Notice of Allowability	Application No.	Applicant(s)	
	10/816,583	MORI ET AL.	
	Examiner	Art Unit	
	Pia F. Tibbits	2838

EXAMINER'S AMENDMENT

Fig. 1

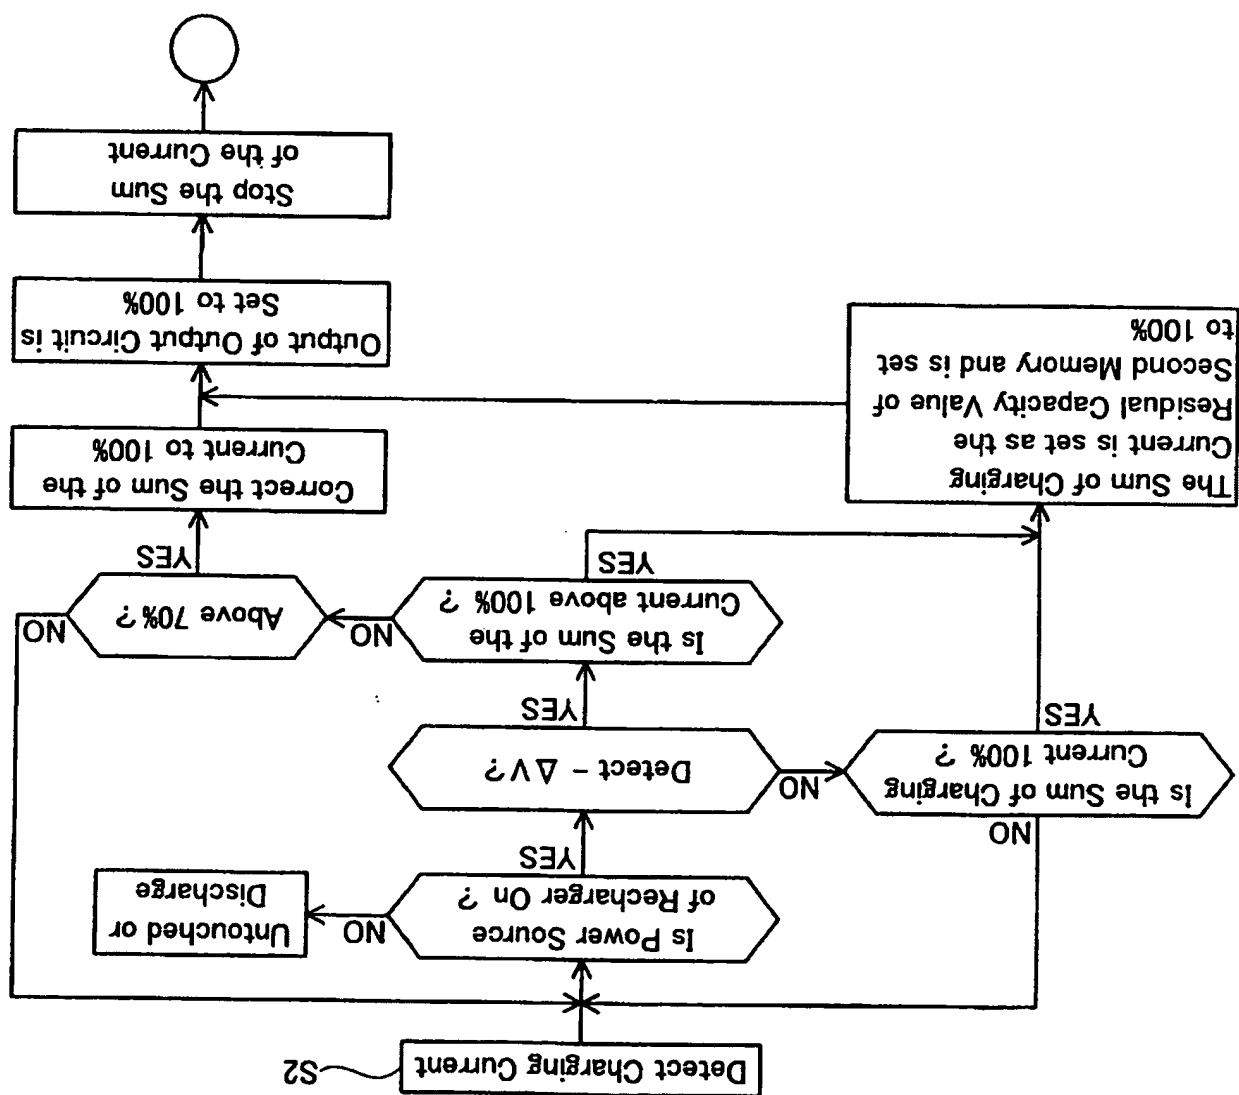
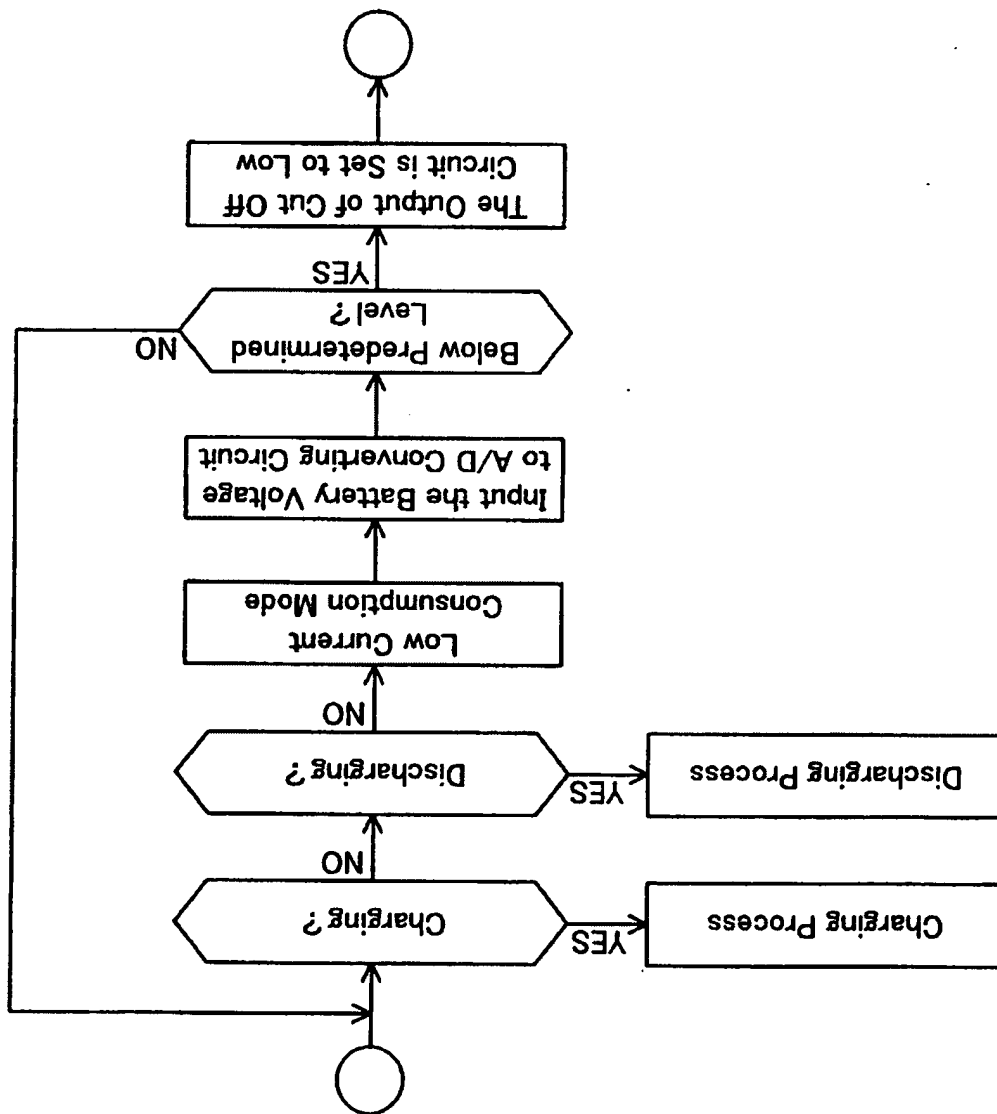
Newly submitted figures 1-4 are not in compliance with 37 CFR 1.121(d) since 1) the newly added limitation "LED display" is not shown, and 2) any amended replacement drawing sheet should include all of the figures appearing on the immediate prior version of the sheet, even if only one figure is being amended. The figure or figure number of an amended drawing should not be labeled as "amended." If a drawing figure is to be canceled, the appropriate figure must be removed from the replacement sheet, and where necessary, the remaining figures must be renumbered and appropriate changes made to the brief description of the several views of the drawings for consistency. Additional replacement sheets may be necessary to show the renumbering of the remaining figures. Each drawing sheet submitted after the filing date of an application must be labeled in the top margin as either "Replacement Sheet" or "New Sheet" pursuant to 37 CFR 1.121(d).

Formal drawings to be submitted.
